Biological Resources Update and
Potential Effects Associated with Fuel
Modification Plan Memorandum

PROJECT NUMBER: 1085-08SAGE

SUBJECT: Biological Resources Update and Potential Effects Associated with Fuel Modification Plan for the Sage Hill School Middle School and Gymnasium Addition Project

ILLUMINATION SUMMARY

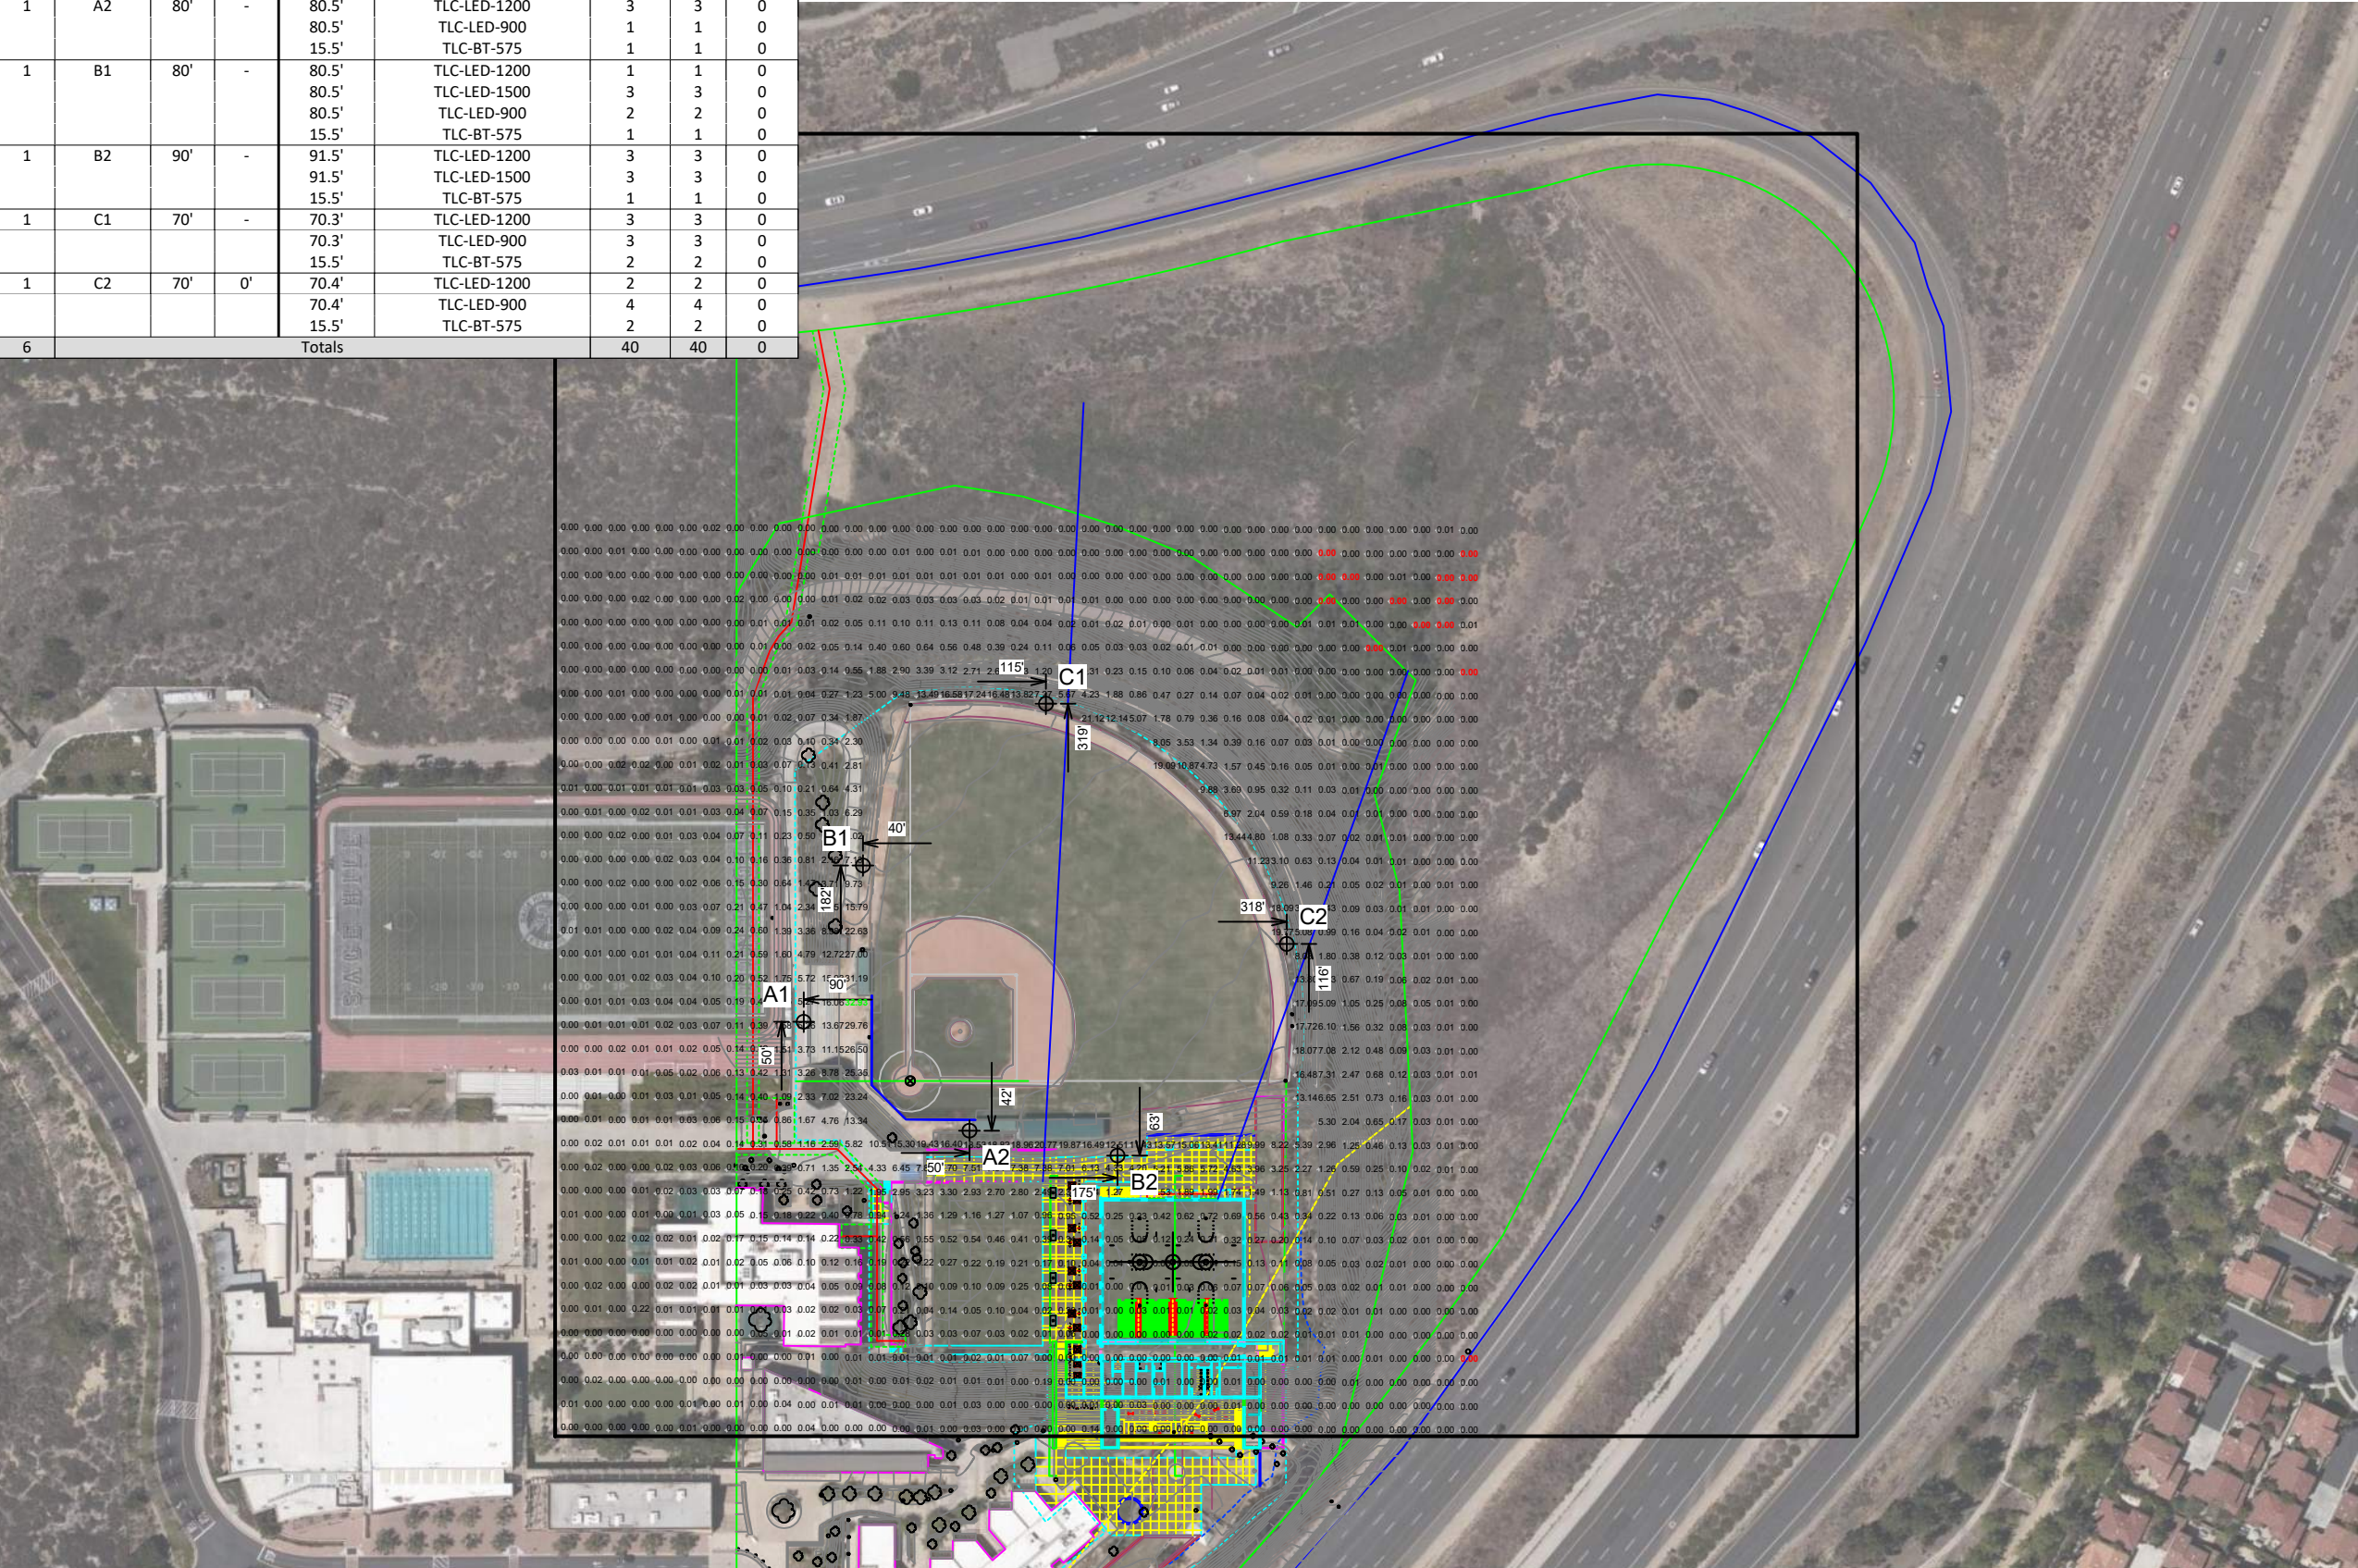
Finally, GLA has reviewed the photometric analysis [Attached] prepared by Musco to determine whether the ballfield lighting would result in light spillage that would result in significant impacts on the coastal sage scrub within the NCCP/HCP boundaries. The photometric analysis shows that the light spillage for areas adjacent to the NCCP area is 0.1-foot candle or less, which is the threshold such that no significant impacts would occur.
